Access Compliance Report

Public Rights-of-Way

(Curb Ramps)

Intersection ID: 10025	Main Street: HORNWOOD_CT	Cross Street: ROTHERBY_CT	Location: SW
ADA ID: 78665422881F	Ramp Type: Perp	Initial Pass/Fail: Fail	Overall Compliance: No
Severity Score: 18.75			
Codes/Mitigation Info/Possible Solution		Field Measurements/Component Compliance

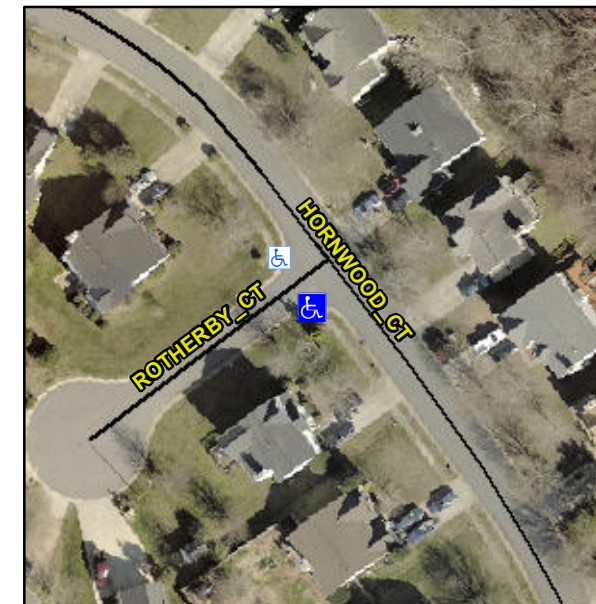
R304.5.1, R304.5.3

Compliance	Description	Data	Compliance	Description	Data
N/A	Ramp Length (in)	46.5	Yes	Ramp Slope (%)	5.6
No	Ramp Width (in)	35.5	No	Ramp XSlope (%)	4.2
N/A	Flare Type LT	N/A	N/A	Flare Type RT	N/A
N/A	Flare Slope LT (%)	N/A	N/A	Flare Slope RT (%)	N/A
N/A	Flare Traversable LT?	N/A	N/A	Flare Traversable RT?	N/A
N/A	Landing Length (in)	N/A	N/A	DWS Provided?	N/A
N/A	Landing Width (in)	N/A	N/A	DWS Contrast?	N/A
N/A	Landing Slope (%)	N/A	N/A	DWS Length (in)	N/A
N/A	Landing X Slope (%)	N/A	N/A	DWS Full Width?	N/A
N/A	Landing Curb? (Y/N)	N/A	N/A	DWS Offset (in)	N/A
N/A	Shared Landing?	N/A			
N/A	Gutter Ponding?	N/A	N/A	Gutter Slope (%)	N/A
N/A	Gutter Lip Ht (in)	N/A	N/A	Gutter X Slope (%)	N/A
N/A	Painted X Walk1?	No	N/A	Painted X Walk2?	N/A
	X Walk 1 Direction	To NW		X Walk 2 Direction	N/A
N/A	X Walk 1 Width (in)	N/A	N/A	X Walk 2 Width (in)	N/A
	X Walk 1 Slope (%)	3.4		X Walk 2 Slope (%)	N/A
	X Walk 1 X Slope (%)	2.2		X Walk 2 X Slope (%)	N/A

Remove & Replace Entire Ramp.
